REMARKS

Serial No. 10/648,058 Inventor: YATES, John SAFETY BELT WEB ADJUSTER Attorney Docket: 31104-6

Annotated Marked-Up Drawing

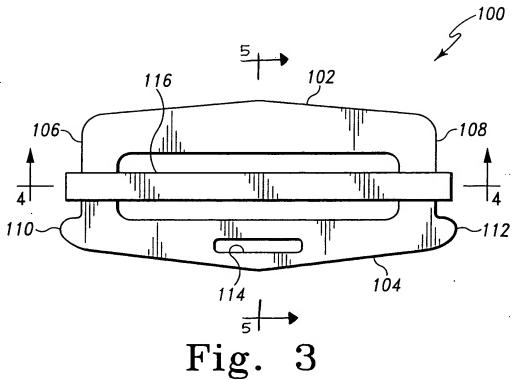
Regarding Figs. 1, 2 and 4, currently no amendments are being made. Regarding Fig. 3, a section line 5-5 has been added to clarify from where the view shown in Fig. 5 is taken. Regarding Figs. 5 and 6, horizontal member 116 was previously shown in the same plane as the horizontal members 102 and 104 of the web adjuster 100. However, in order for the web adjuster 100 to operate properly and lock the seat belt webbing portions 132 and 134 in place, the horizontal member 116 must be able to slide over the vertical members 106 and 108, as shown in Fig. 4. In Figs. 5 and 6 as originally filed, the vertical members 106 and 108 are incorrectly shown in the same plane as the horizontal members 102 and 104. Therefore, Figs. 5 and 6 have been amended to show the proper location of horizontal member 116, which is offset from the plane created by the horizontal members 102 and 104. The amended drawings now show the ability of the horizontal member 116

Separate papers proposing red-line corrections to Figs. 3, 5 and 6 entitled Annotated Marked-Up Drawings are provided herewith in accordance with 37 C.F.R. §1.121(d)(1). Also enclosed are Replacement Sheets incorporating the changes in anticipation of approval of the amendments proposed herein.

Fig. 5

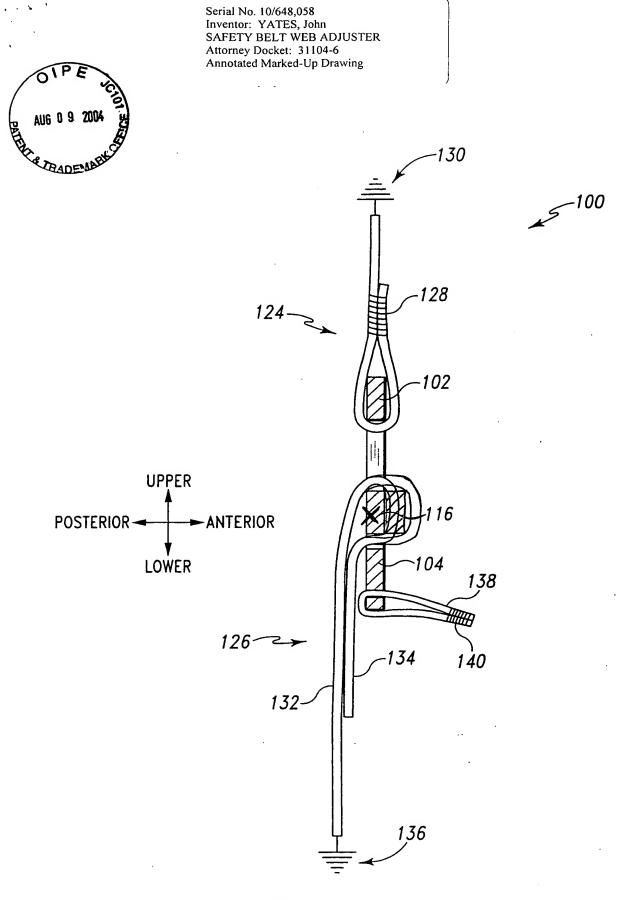
to slide freely over the vertical members 106 and 108, as clearly shown in Figs. 3 and 4 as originally filed, and as disclosed in the specification as originally filed.

The specification as originally filed discloses throughout that the horizontal member 116 is able to slide freely over the vertical members 106 and 108. Specifically, on page 7 at lines 21-22, the specification provides that "[t]he c-shaped ends 120 and 122 [of horizontal member 116] allow the horizontal member 116 to slide freely over the vertical members 106 and 108, as shown in the drawings." Further, on page 11 at lines 3-6, the specification provides that "[i]t will be appreciated that the ability of horizontal member 116 to slide freely along vertical members 106 and 108 is critical to the ability of web adjuster 100 to be easily adjusted when in the position illustrated in FIG. 6."
